IMPORTANT SAFETY RECALL RECALL NO. 17E061

December 2017

This campaign involves mounting brackets (Part Nos. AB037A-100, AB037A-100P, AB037A-100B) in ProCharger supercharger kits, intended for installation on Model Year 2012 – 2017 Jeep Grand Cherokee SRT8/SRT vehicles in the US and Canada. These mounting brackets were included with the following kits:

New Bracket

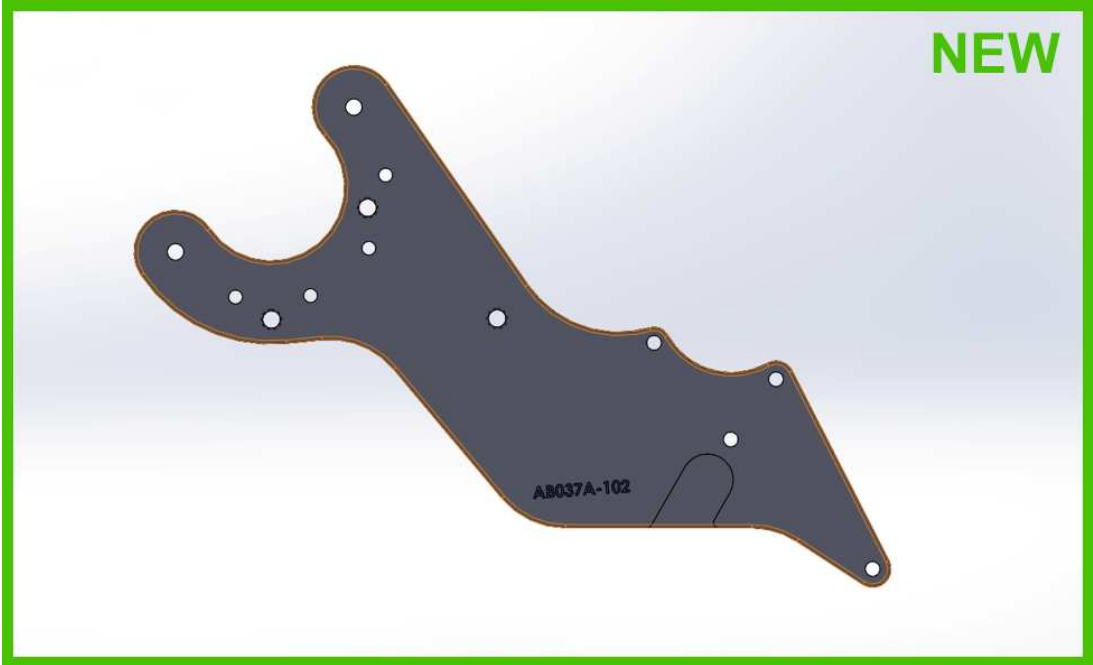
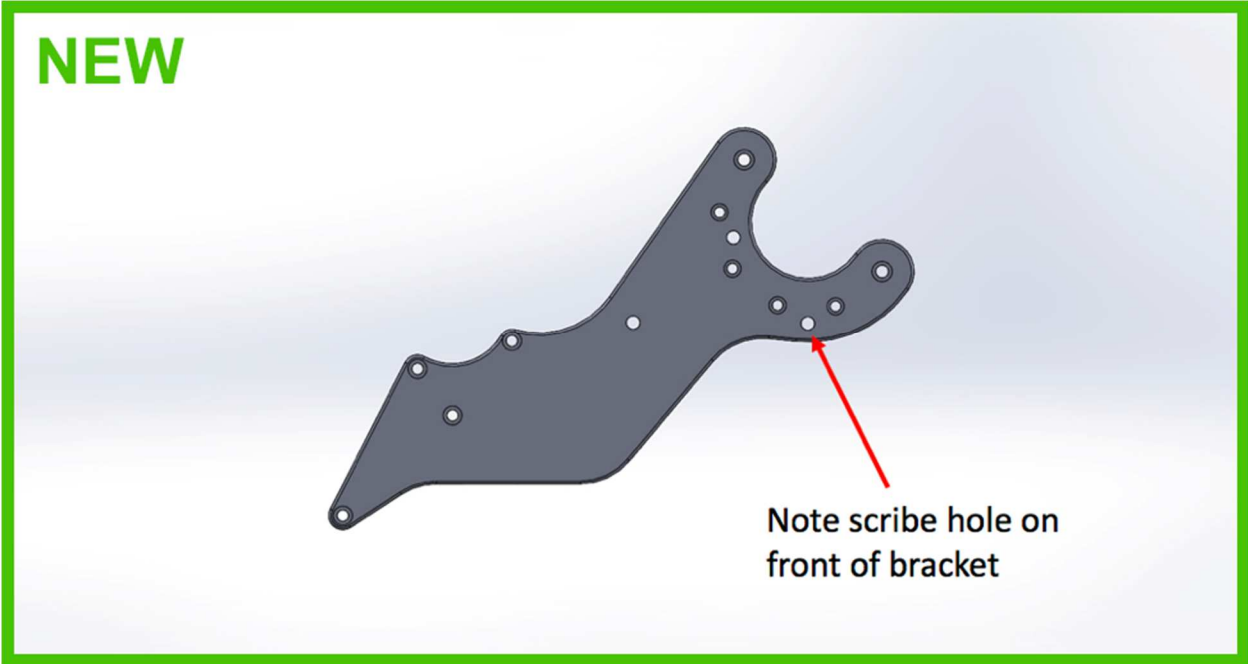
If you have one of the vehicles listed above, a visual inspection will easily identify whether you have a kit or system covered by this recall. The replacement part can be visually identified by the addition of an unused scribe hole on the front (forward) facing side of the new replacement bracket (See top two illustrations above, outlined in green).

Satin Finish: AB037A-102
Black Finish: AB037A-102B

Polished Finish: AB037A-102P

RECALLED BRACKET

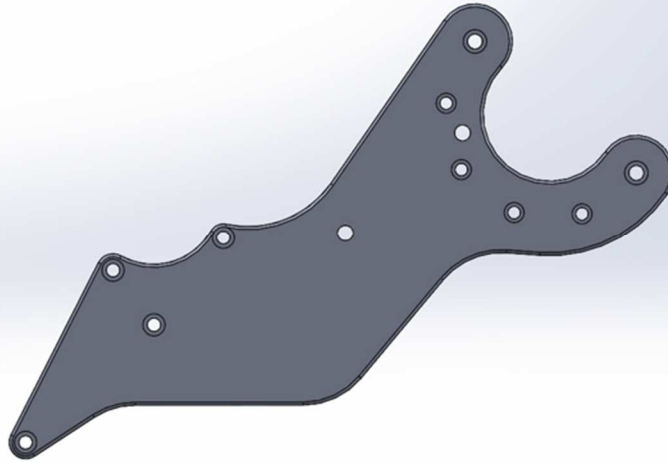
ProCharger has discovered that the compressor housing for the above listed applications may, over time, contact the ABS brake lines due to insufficient clearance afforded by the mounting. Contact with the brake lines could compromise the integrity of the line. This contact between the bracket and brake line can occur under a variety of circumstances including improper bracket installation, variation in the engine mount positions within the vehicle manufacturer’s specifications (which potentially results in the bracket being placed close to the ABS line), and/or possible degradation of the motor mount over time that may increase movement of the engine. If this condition remains undetected, the compromised integrity of the ABS brake line could eventually result in loss of brake fluid and degraded braking performance, increasing the risk of a vehicle crash.

Please schedule an appointment at your earliest opportunity with the dealer that sold and/or installed the kit/system. If you self-installed, ATI ProCharger can support you directly. If you own one of the kits containing the recalled mounting brackets, ATI will send you an improved bracket for remounting the supercharger either directly to you, if your ProCharger was self-installed, or to your local dealer, and reimburse you for the cost of remounting the supercharger.
